VISTA CHEMICAL COMPANY

VCM TANK FARM COMPRESSOR UPGRADE PROJECT

VCM TANK FARM COMPRESSOR UPGRADE
PROCESS HAZARD ANALYSIS COMPLETION REPORT

3	9/13/87	JAL		
2	10/22/87	CONSTRUCTION	YVM	
1	10/22/87	COMPRESSIONS	VPM	
ISU	DATE	DESCRIPTION	BY	CKD
VISTA Vista Polymers				
Aberdeen, Mississippi				
VCM TANK FARM COMPRESSOR				
UPGRADE				
P & I D				
SCALE:				
APP'D:	DATE:	No.

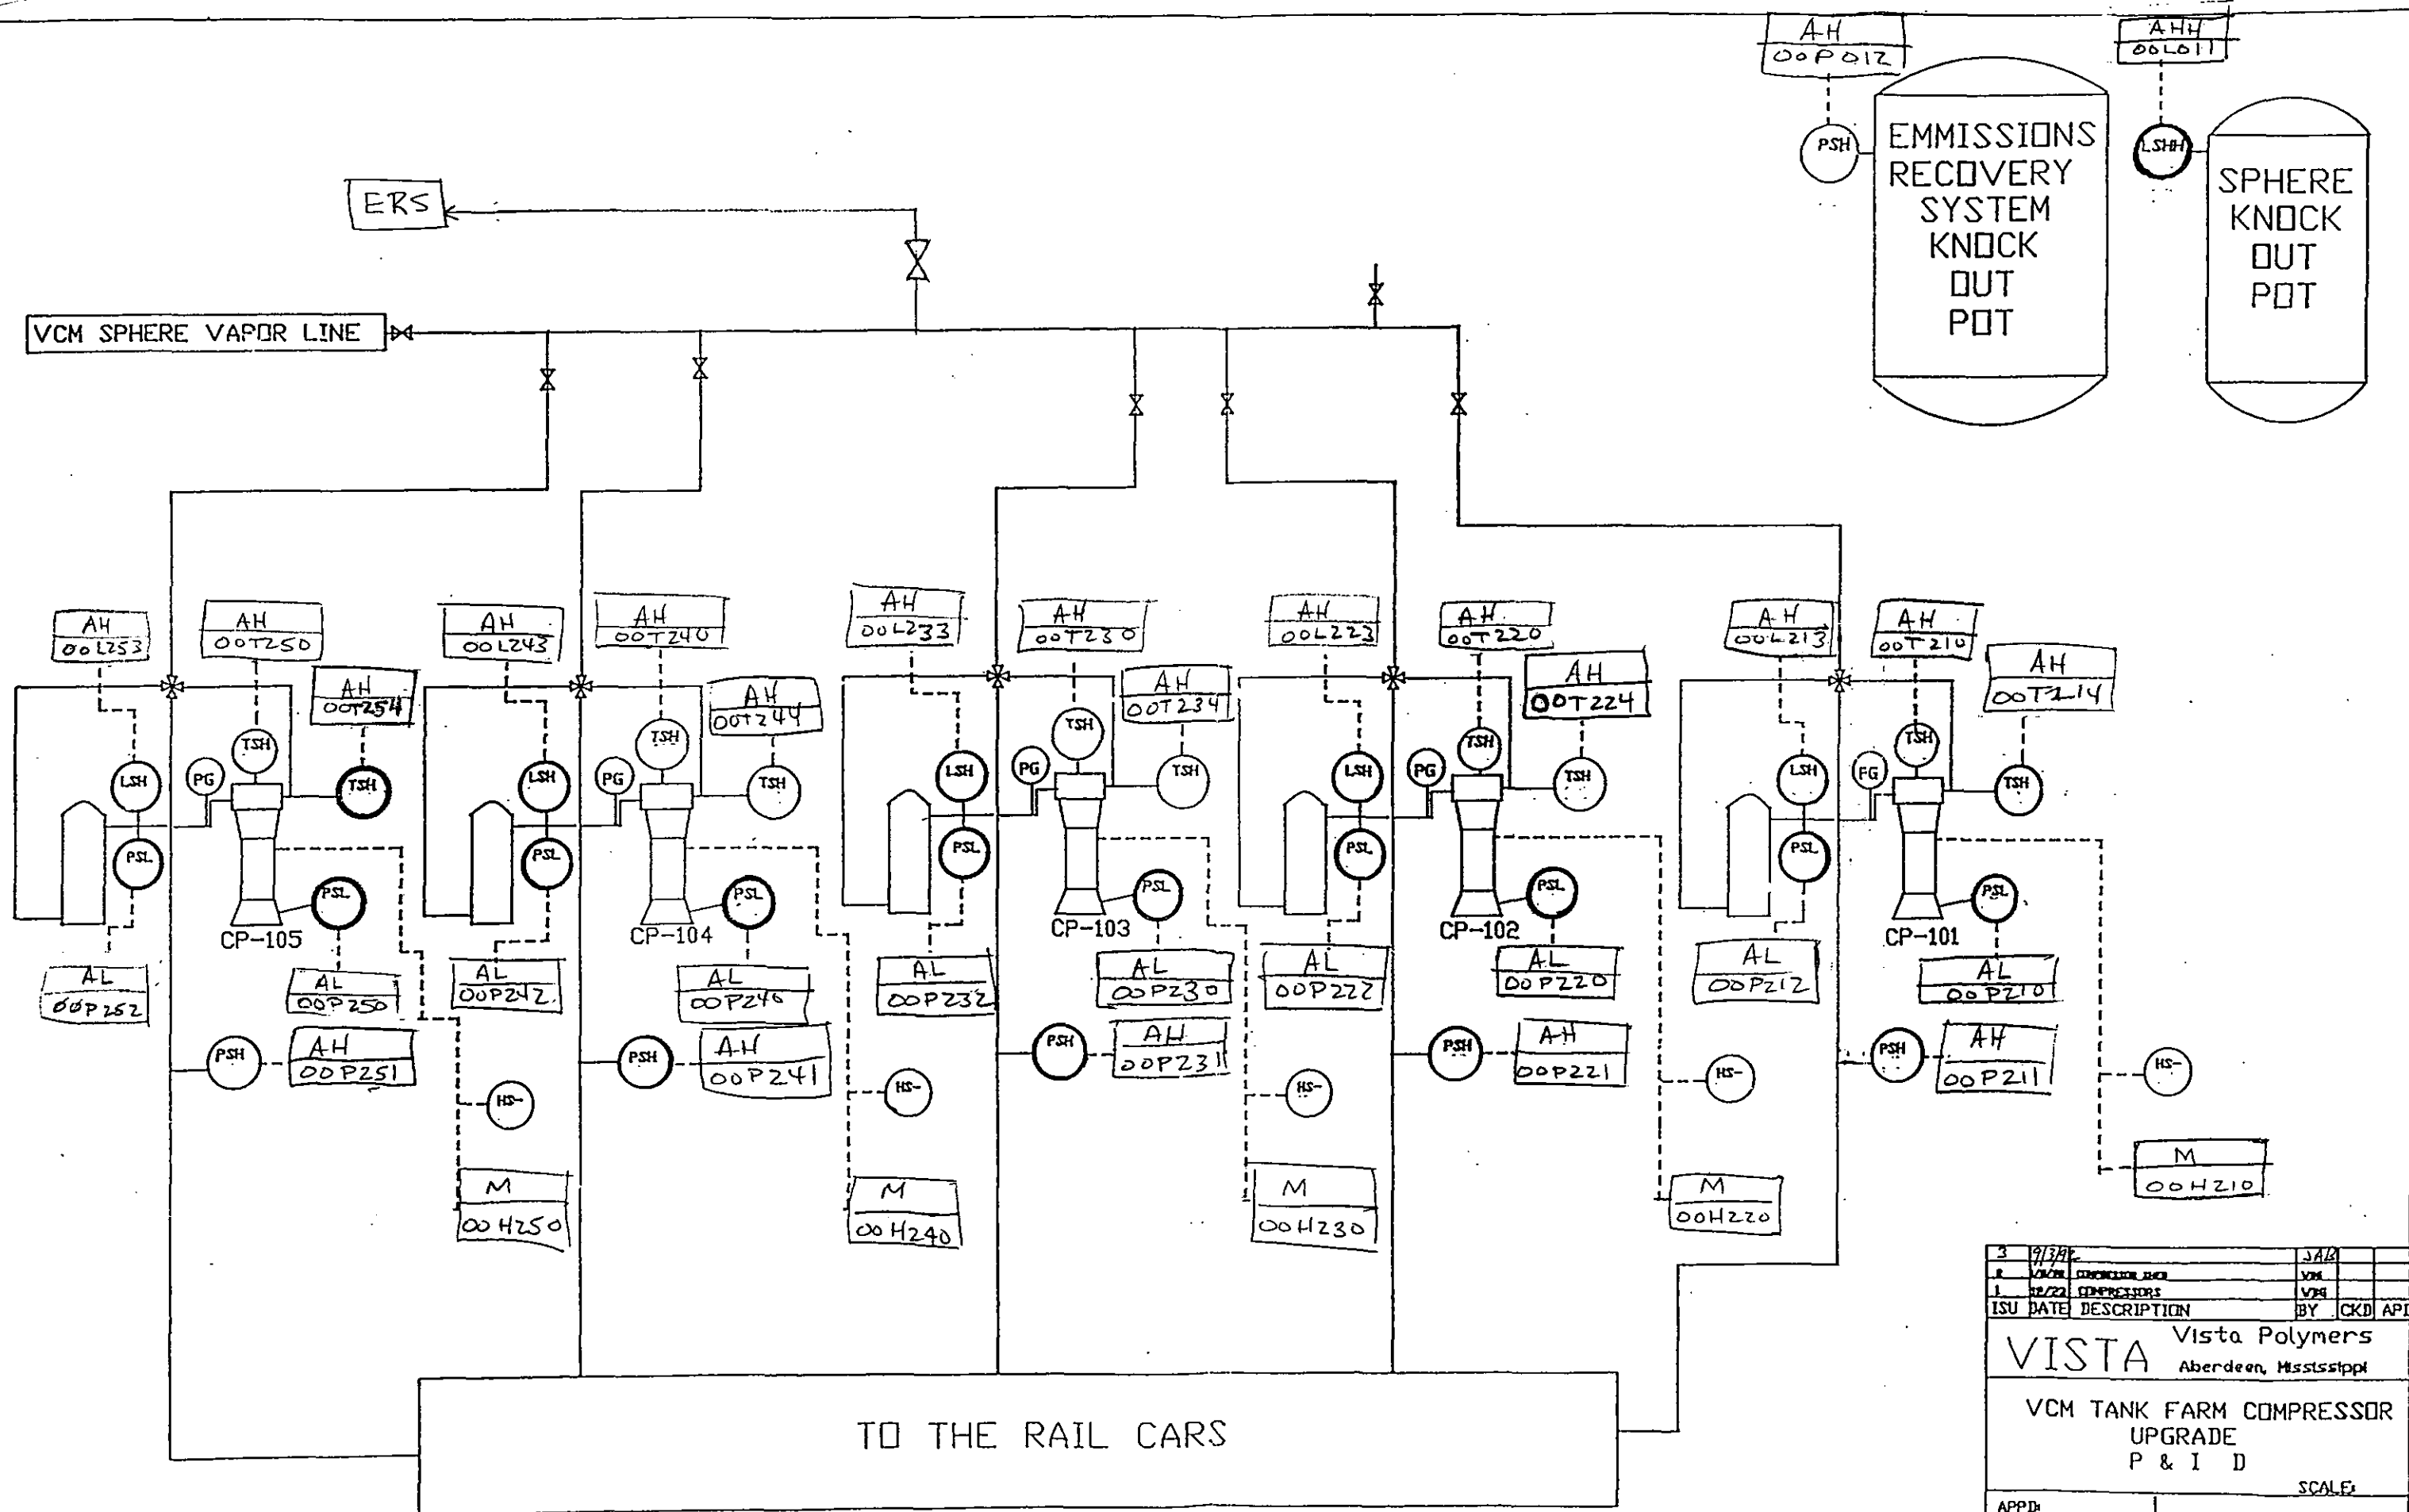
1. CAUSE: Failure or accidental closing of the VCM vapor valve (00HV103) from the sphere, the liquid VCM valve (00HV102) to the sphere, or the railcar isolation valve (00XV120).
- CONSEQUENCE: Cavitation or dead-heading of the VCM compressors. This could potentially damage the compressors and subsequently cause a VCM leak.
- RECOMMENDATIONS: Include the inputs for these valves in the compressor interlocking, such that the compressors are shut down when any of these valves are closed.
- RESOLUTION: The above recommendation has been implemented into the electrical design and operating procedures.
- RISK RATING: 4
